Elizabeth Cook Burntside Lake

GL 7 S23, T63N, R13W Morse Township

VARIANCE REQUEST

The applicant is requesting relief from St. Louis County SSTS Ordinance 61 to allow a Subsurface Sewage Treatment System at a reduced shoreline setback.

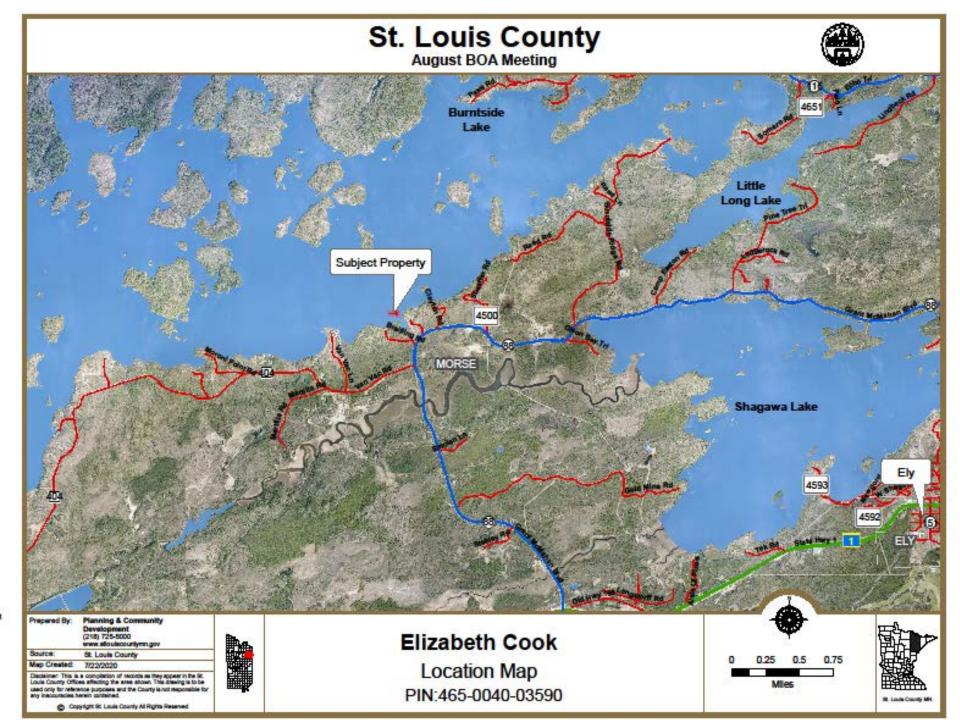
Proposed lake setback of 24 feet: 75 feet required.

- 1. There shall be no increased water usage on the subject parcel.
- 2. The lake setback shall be maximized to the greatest extent possible and shall be no closer than 24 feet to the Ordinary High Water Level.
- 3. The proposal shall adhere to all county, state and federal regulations.

Existing drywell location

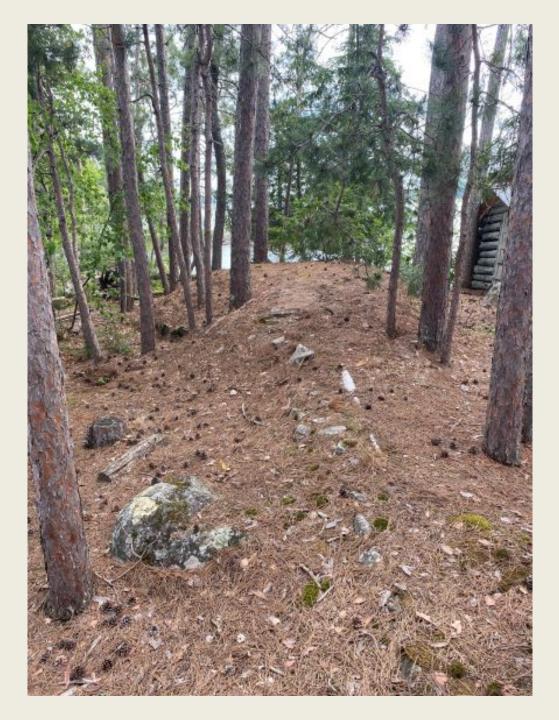
Existing: The property is currently served by a drywell and unapproved graywater disposal. The drywell is located approximately 22 feet from the OHWL
